INFORMATION BULLETIN #17

SUBJECT BLOWER HOUSINGS, Revised Procedure for Installing

FILE IN MS-4750

MODEL SERIES 95900, 98900, 10A900

Fig. 1

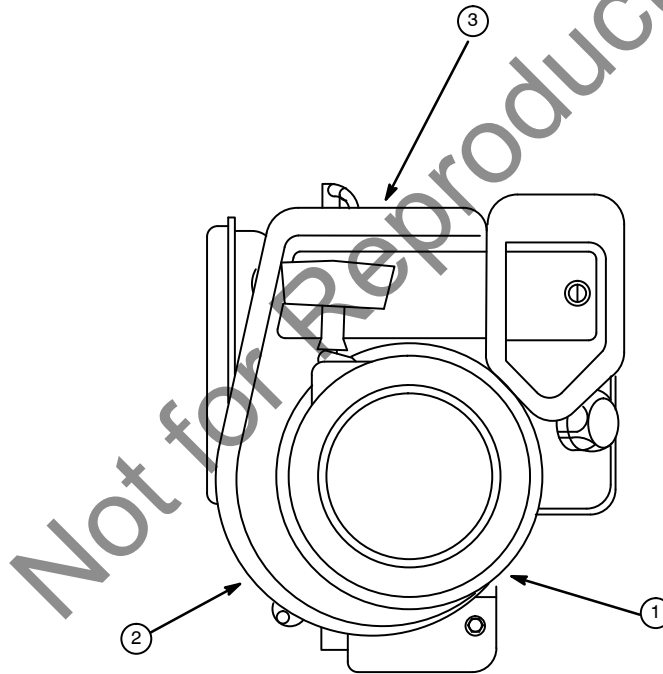
Blower housing screw tightening sequence, Fig. 1, is recommended whenever a blower housing is being removed and/or installed. Torque screws to 85 in. lbs.
